Proposal for Amendment 3 to UN Global Technical Regulation No. 6 (Safety glazing)

Amendment 3 to UN Global Technical Regulation No. 6 (Safety glazing)

Annex 7.1. paragraph 7.1.3.3., amend to read:

Figure 4
Determination of Zone I

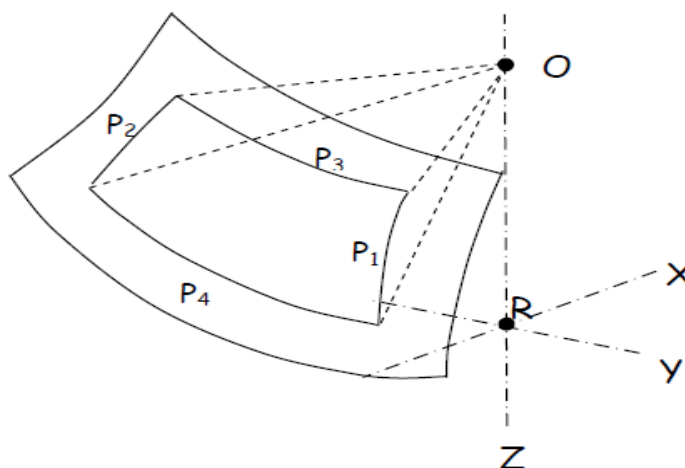
"7.1.3.3. Determination of the Test Areas for Category 1-2 and 2 Vehicles using the "O" Point.

7.1.3.3.1. The straight line OQ which is the horizontal straight line passing through the eye point "O" and perpendicular to the median longitudinal plane of the vehicle.

7.1.3.3.2. Zone I is the zone determined by the intersection of the windscreen with the four planes defined below:

In addition, opaque obscuration can be exempted in Zone I. It is the limited areas where it is intended that a sensing device, e.g. a rain-drop detector, rear view mirror or autonomous sensors, will be bonded to the inner side of the windscreen. The opaque obscuration where such devices may be applied is defined in paragraph 7.1.3.3.3. of this annex.

P1 a vertical plane passing through point O and forming an angle of 15° to the left of the median longitudinal plane of the vehicle;

P2 a vertical plane symmetrical to P1 about the median longitudinal plane of the vehicle.

If this is not possible (in the absence of a symmetrical median longitudinal plane, for instance) P2 shall be the plane symmetrical to P1 about the longitudinal plane of the vehicle passing through point O.

P3 a plane passing through a transverse horizontal line containing O and forming an angle of 10° above the horizontal plane;

P4 a plane passing through a transverse horizontal line containing O and forming an angle of 8° below the horizontal plane;
